Eisenhower East Hoffman Proposals

**Department of Planning and Zoning
Planning Commission Meeting
February 7, 2006**

DEPARTMENT OF PLANNING AND ZONING
Hoffman Staff Report

Docket Item #12 A-G
DSUP #2005-0031 thru 0035, CDD #2005-0002
SUP (TMP) #2005-0115
HOFFMAN DEVELOPMENT

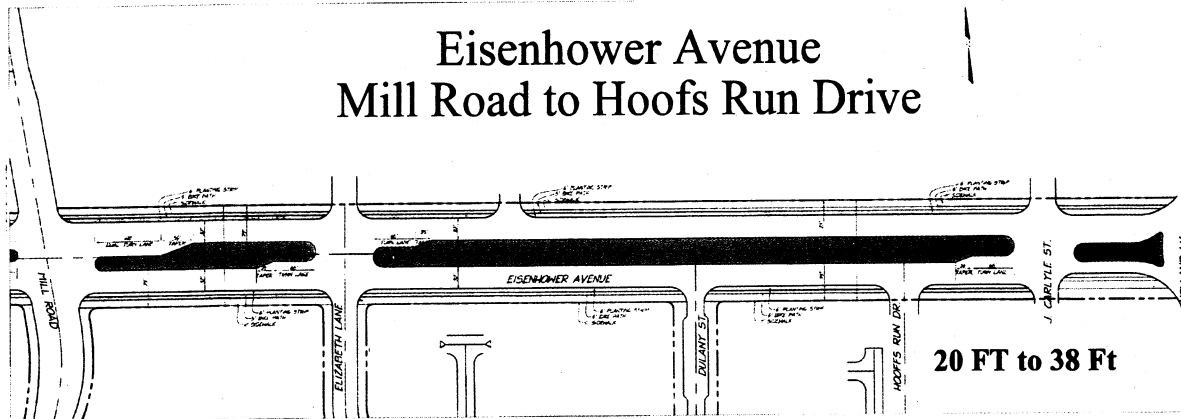
The EESAP envisioned a broad green landscaped median as one of the character-defining elements of Eisenhower East, unifying development along its expanse and providing a pedestrian refuge, open space and public amenity for residents and businesses in the City. The applicant's initial proposal showed a median for Eisenhower Avenue that was only 4 ft. wide at some places and never exceeded a width of 25 ft.

At the Planning Commission work sessions on December 6, 2005, the median issue was discussed at length with the conclusion that a reduced median would not be consistent with the EESAP, as the community and the City envisioned it. The Commission directed staff to work with the applicant on the configuration of Eisenhower Avenue to provide more of the anticipated open space, pedestrian access and aesthetics that a well-designed boulevard would create. While the Commission acknowledged the need for the roadway to effectively move cars, it specifically directed staff to focus less on simply moving cars and more on the need for Eisenhower Avenue to become a signature, unifying spine for the development area. In addition, the Commission suggested that staff hold a public work session, with experts in the field of urban transportation to balance vehicles, pedestrians and open space.

The applicants have subsequently submitted alternate revised plans, which rearrange dimensions, and achieve a greatly enhanced median, providing open space and pedestrian refuge, while still maintaining the travel lanes necessary to accommodate East Eisenhower traffic.

The width of each vehicular travel lane has been decreased from 11 ft. to 10 ft. With three travel lanes eastbound and three westbound, this change effects an overall reduction in paving width of six feet, which can contribute to the central median.

The width of the sidewalk area has been revised to be 22 feet and, instead of providing only one bike path on the south side of Eisenhower Avenue from Stovall to Mill Road, as identified in the EESAP, there can be a bike path on both the north and the south sides of Eisenhower Avenue from Stovall to Holland Lane. In both cases, the bike path will be accommodated as part of the planned 22 foot wide sidewalk area.

Consistency with EESAP

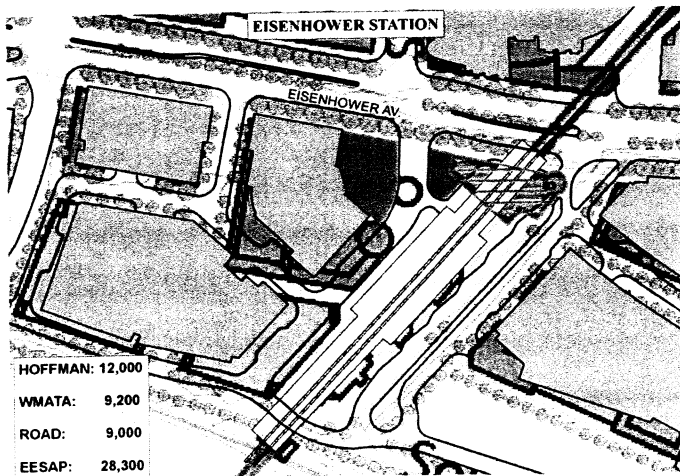
The configuration of the Eisenhower Station Plaza has been revised from the EESAP as a result of the new north-south extension of Swamp Fox Road. Creating a four-way intersection at Eisenhower Avenue and Swamp Fox Road was necessary to provide traffic circulation and access to Blocks 9A and 9B. As a result of the new road, what had been planned as a single large plaza will be separated into two open spaces, one adjacent to the Metro station and the other located directly across the street from the Metro entrance.
